Dolby Laboratories Inc

Field Bulletin 222

CP65 with DA20

Incorrect Wake-up Format after Power-up

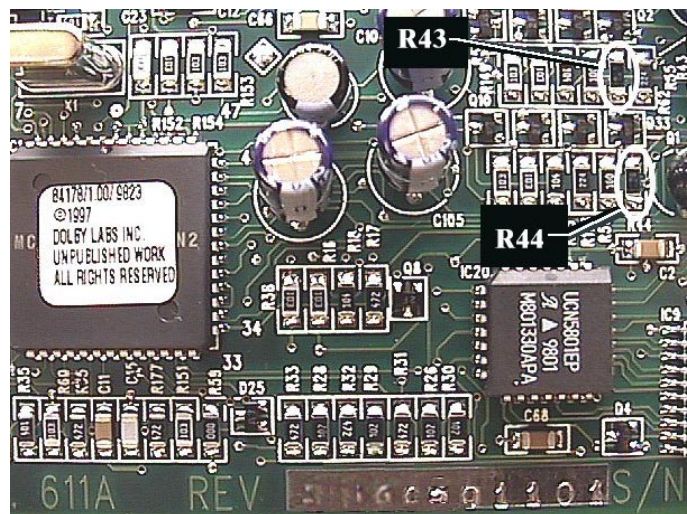
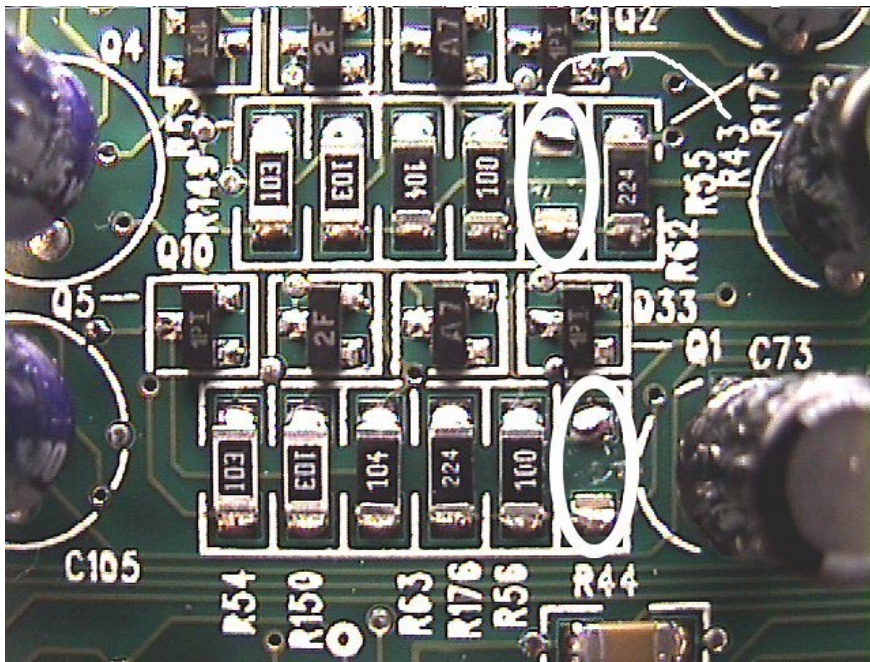
During the initial power-up sequence, a CP65 connected to Model **DA20** goes into format 04 or 05 even though the wake-up jumper on the CP65 is set to a different wake-up format. This occurs only with the **initial power-up**. The unit otherwise functions correctly.

A section of the Cat. No. 611A circuit in the DA20 does not stabilize until **after** the wake-up pulse from the CP65 is received. This causes the Cat. No. 611A to issue an arbitrary format 04 or 05 pulse.

Remove two resistors, which will disable the circuit without affecting DA20 functions. The circuit causing the erroneous pulse is not necessary for proper DA20 operation.

1. Shut off the power to the DA20.
2. Remove the 12 front panel mounting screws.
3. Remove the Cat. No. 611A card from the last right-hand slot.
4. Referring to the figures below, locate resistors R43 and R44.

- Using a small sharp-pointed cutter located at the center portion of the resistor body, shatter each resistor. The resistors should break away cleanly and leave no connections. **Use care to prevent the cutter's sharp tips from damaging any traces on the board beneath the resistors.**

Do not use a soldering iron. A hot soldering iron can damage the surrounding surface-mounted components or PC board traces.
